Date: 05/01/2022
PINS Refs: APP/X5210/W/21/21/3284632
Our Ref: 2021/1650/P &
2021/2254/L
Contact: A Greenhalgh
Direct Line: 020 7974 6341
Adam.Greenhalgh@camden.gov.uk

32A Chalcot Square, LONDON, NW1 8YA

Appeal Statement in support of the refusal of LB Camden planning application and Listed Building Consent applications : 2021/1650/P & 2021/2254/L for 'Replacement of window at front of lower ground floor flat with French doors (2021/1650/P & 2021/2254/L); removal of internal walls (bathroom) and erection of new partition walls to form new bedroom and bathroom (2021/2254/L only)'

Existing front
elevation A

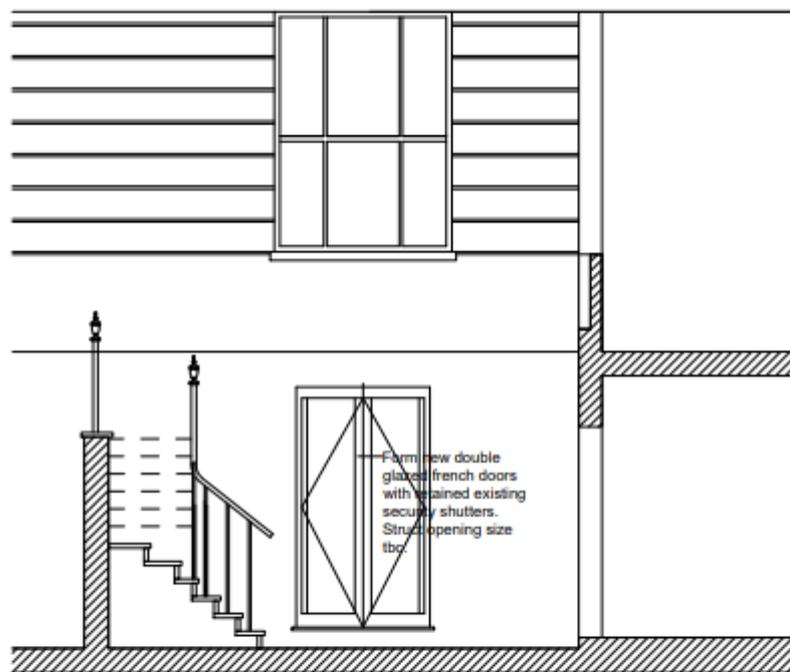
The historical sash window in the middle of the front elevation at lower ground floor level is indicated on the application existing elevation below:

The new French windows at basement level would result in the loss of a traditional sash window which is representative of when the building was used a single house with an ancillary basement.

No evidence has been submitted to show that the distinctive sash windows at the fronts of the basements have been replaced with French windows at any of the other listed buildings in the terrace.

The proposed French windows are not compatible with the heritage of the building which, as can be evidenced by the statutory listing was a single house with ancillary accommodation at basement level.

The replacement of the sash window in the front elevation at lower ground floor level would result in 'less than substantial harm' to the heritage assets, the Listed building and the Conservation Area.
